PROGRESS REPORT (FIRST DRAFT)
U.S. Army Corps of Engineers Waterways Experiment Station
Corps of Engineers Contract No. DACW39-92-M-6666

STRIP DRAIN TEST SECTION IN CRANEY ISLAND DREDGED MATERIAL MANAGEMENT AREA

NOTE TO REVIEWERS

This is a first draft of a progress report describing the vertical strip drain test section in the Craney Island Dredged Material Management Area. It is estimated that the dredged fill and marine clay will reach 90 percent consolidation in February or March, 1994. As a result, the data pertaining to the test section will be augmented as consolidation progresses. The main purpose of submitting this progress report for review is to obtain suggestions for improving the data presentation and analysis prior to completion of the project. It is anticipated that the input of reviewers at an early stage will improve the final report. Upon completion of the test section and incorporation of the final test results, the report will be submitted for a final review. Thank you in advance for contributing to the improvement of this research.

Figure 33. Measured and Estimated Time Rate of Consolidation Settlement for Main Test Section

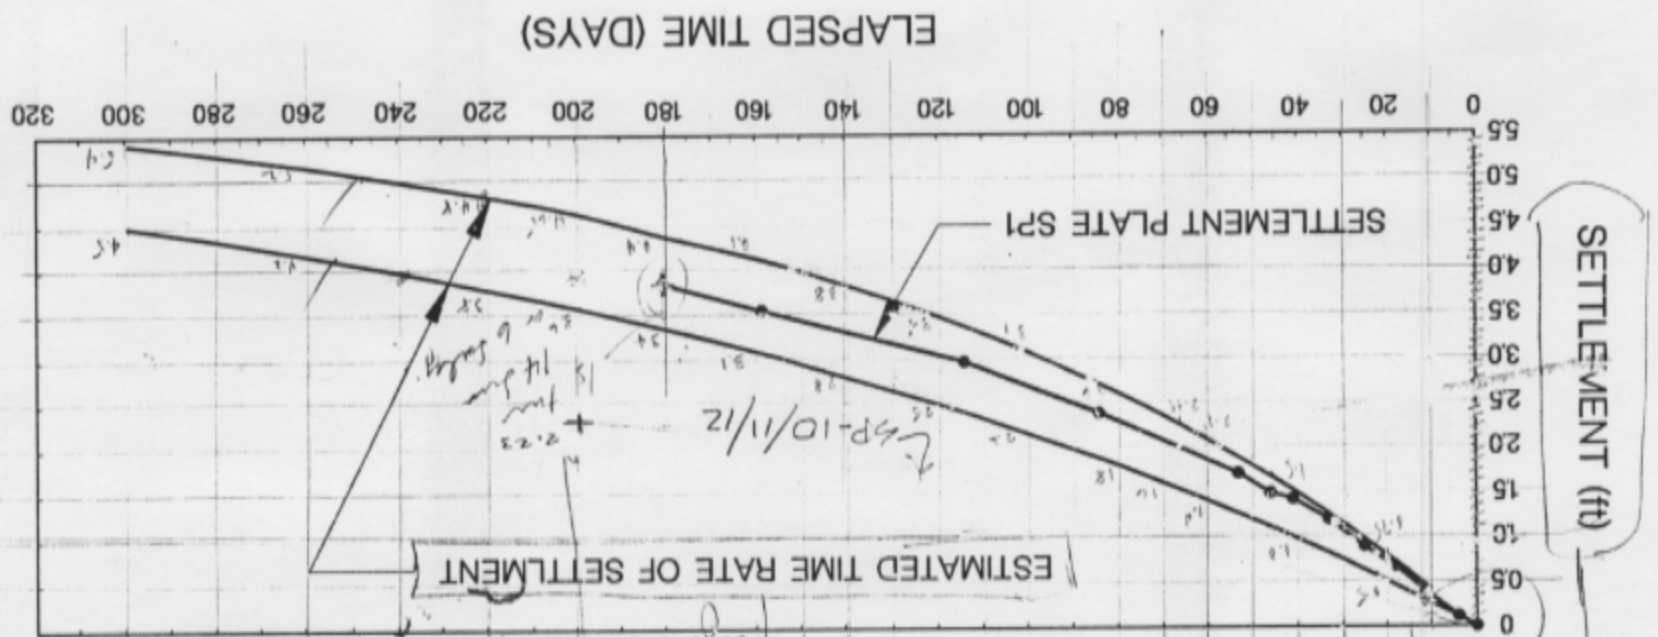
Estimated settlement did not address surcharge. Should compare against SP-10. See comments on Page 34 & 35.

Figure 34. Typical Piezometer Measurements in Test Section

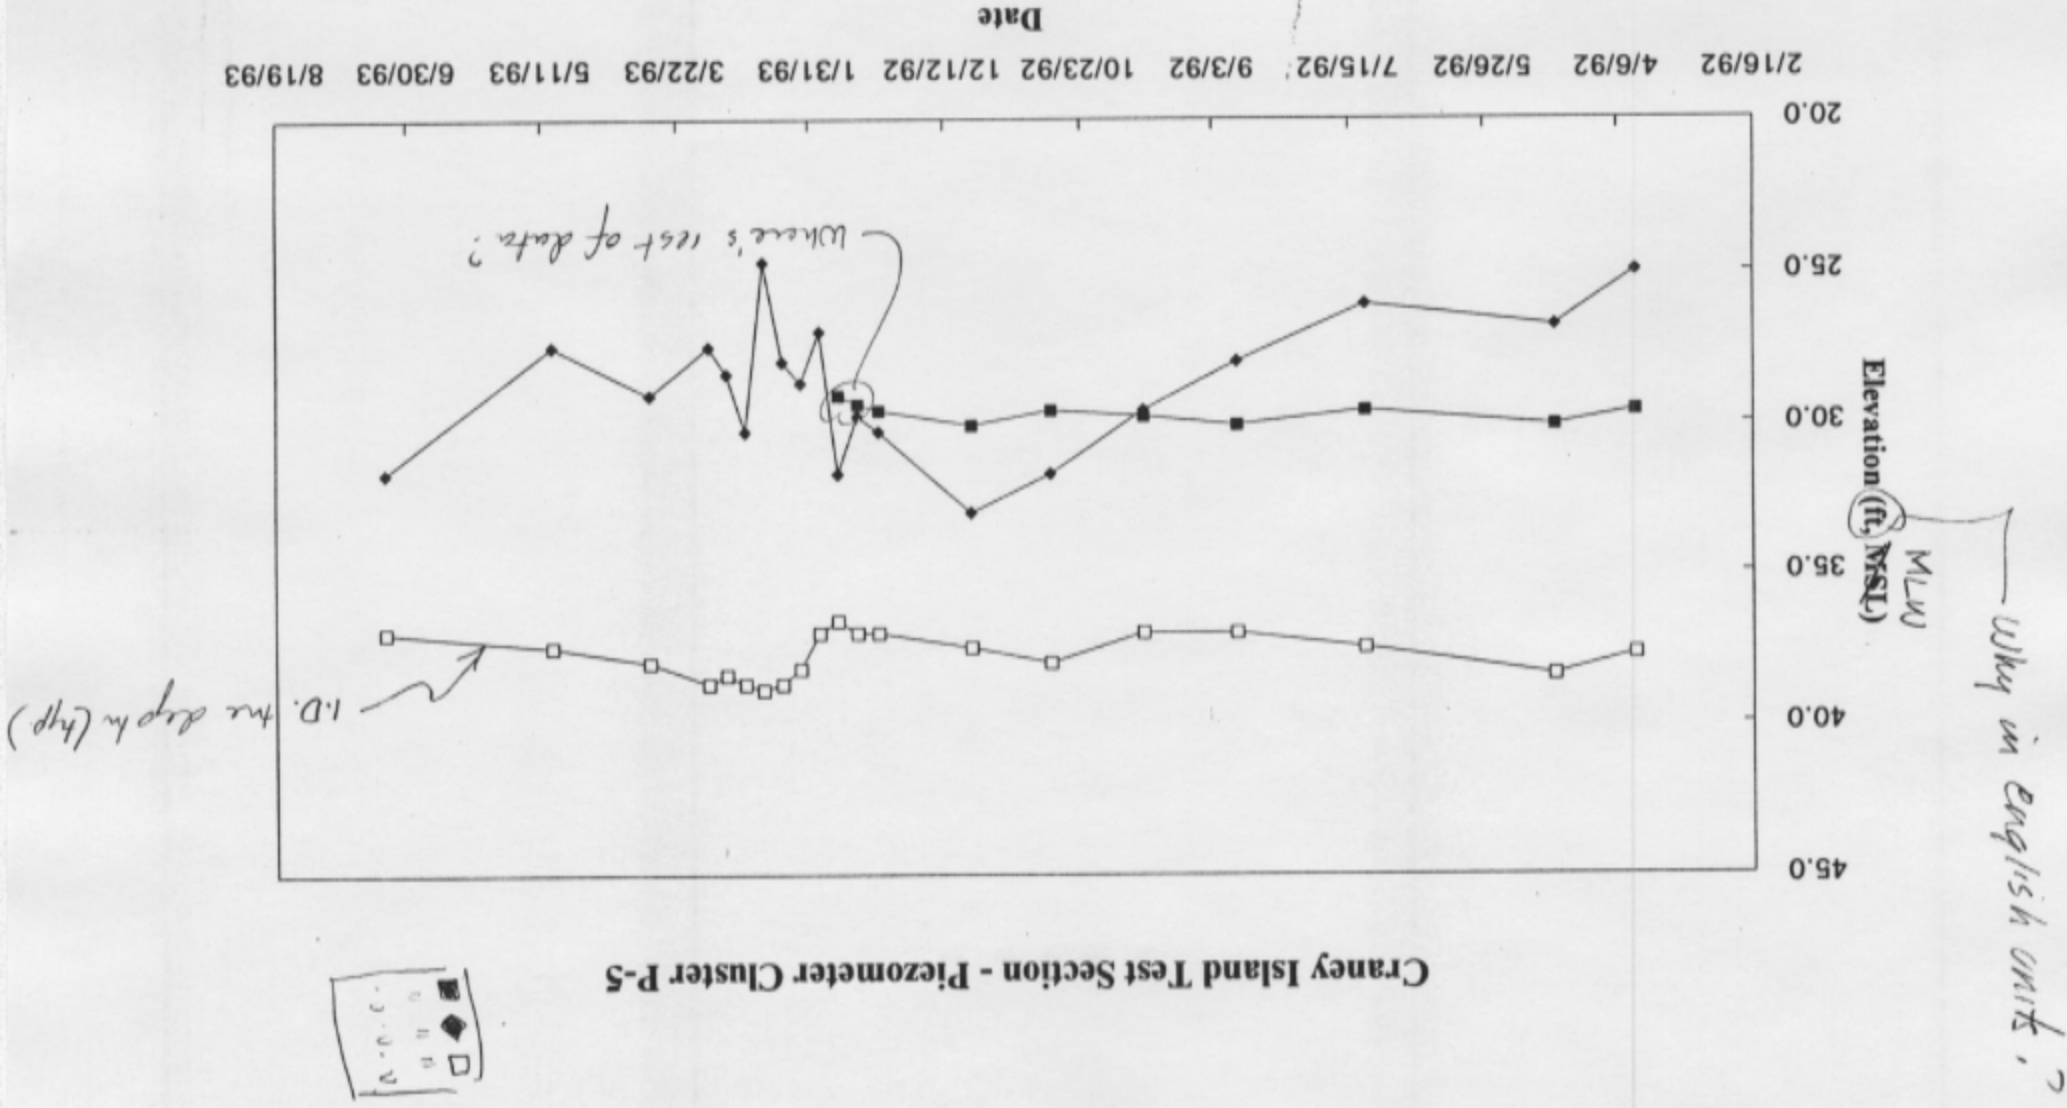
Explain Staff data from Different groups. Why units in english units?
